8CMA20-8/15.12-01 ES

8CMA20-8/15.13-01 ES

Sensors board

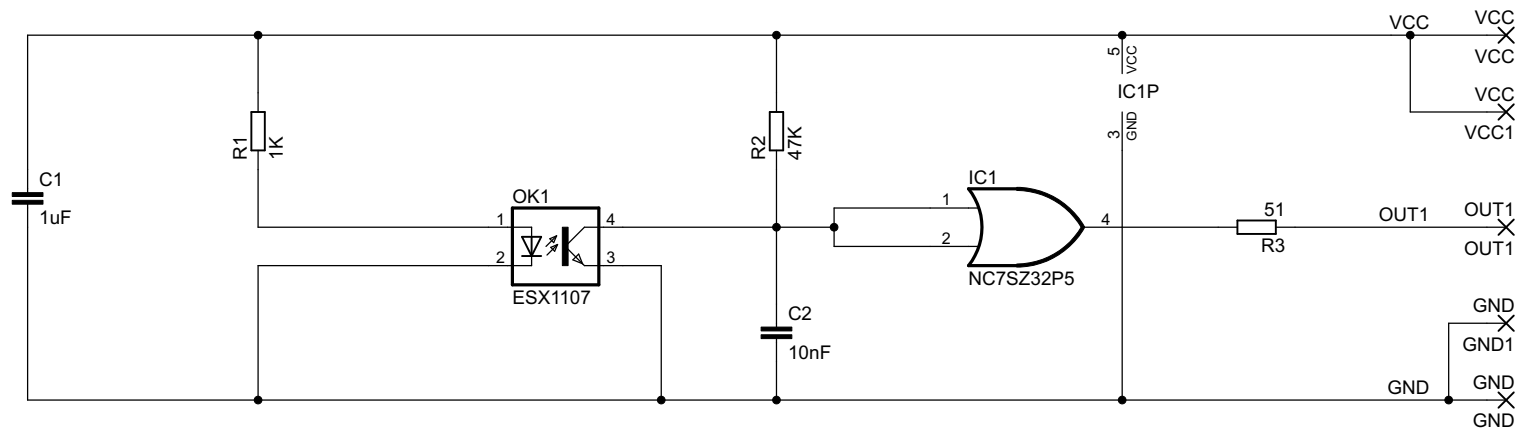
IC of type NC7SZ32P5 allowable to change to NC7SZ08P5, SN74LVC1G08DCKR, SN74LVC1G32DCKR without functionality change.

On special order IC of type NC7SZ32P5 can be changed to NC7SZ04P5, NC7SZ14P5, SN74LVC1G04DCKR, SN74LVC1G14DCKR with inversion of output logic
